Meridian Township
5151 Marsh Road
Okemos, MI 48864

February 12, 2026

Re: Opposition to Proposed Oneida to Sabine Lake 345KV Electric Transmission
Line Route through Meridian Township

EXHIBIT A

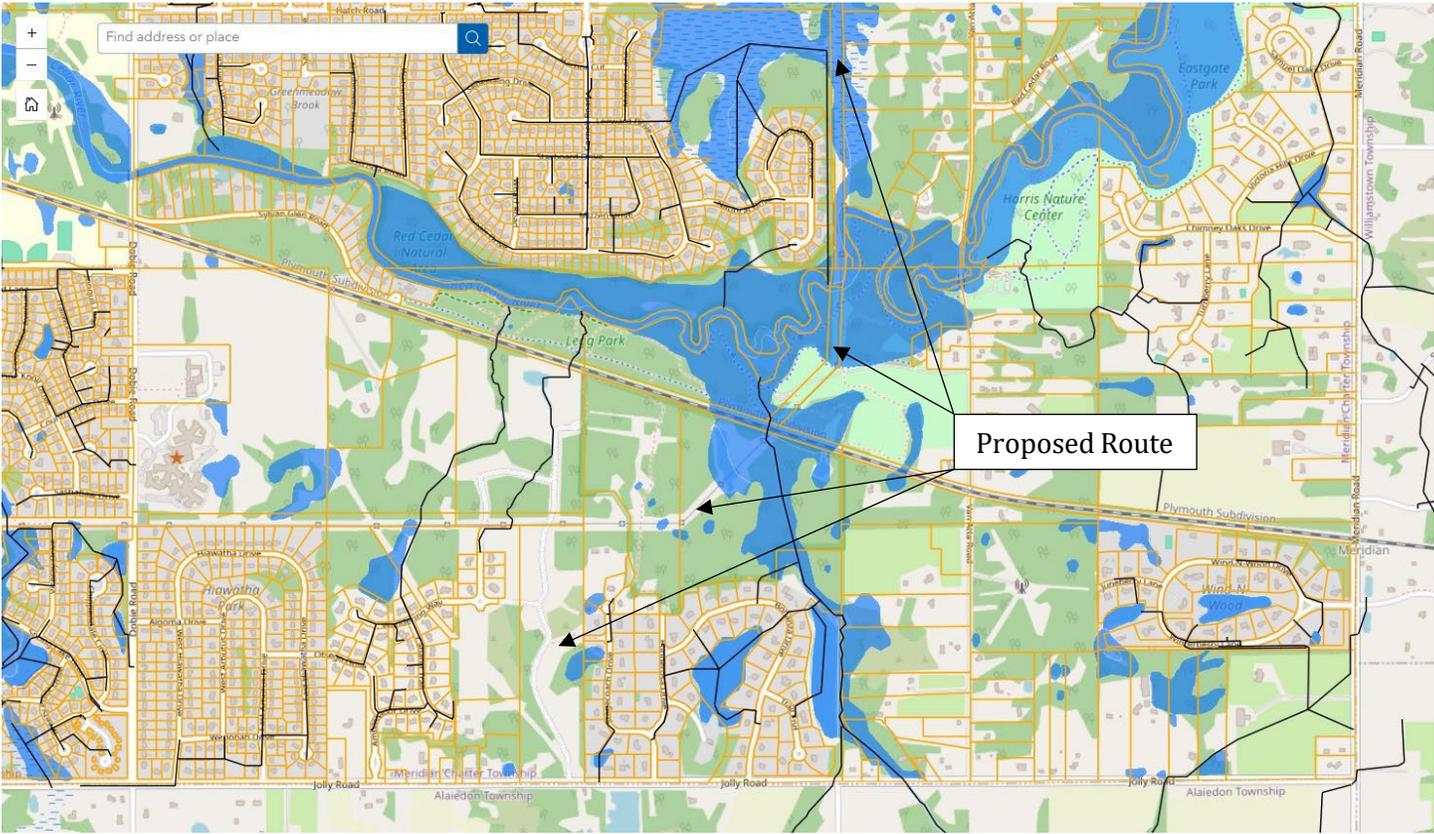
Furthermore, the project poses a direct threat to critical wetlands and riparian zones, risking the alteration of hydrological cycles and negatively impacting biodiversity. Specifically, the proposed route through Meridian Township would have to cross many acres of wetlands, as shown in Exhibit A. The proposed route would also have to cross the floodway of the Red Cedar River, as shown in Exhibit B. Additionally, the required tree clearing near wetlands and in the floodway of the Red Cedar River would worsen the drainage in these areas by reducing the amount of water that is absorbed by these existing trees.
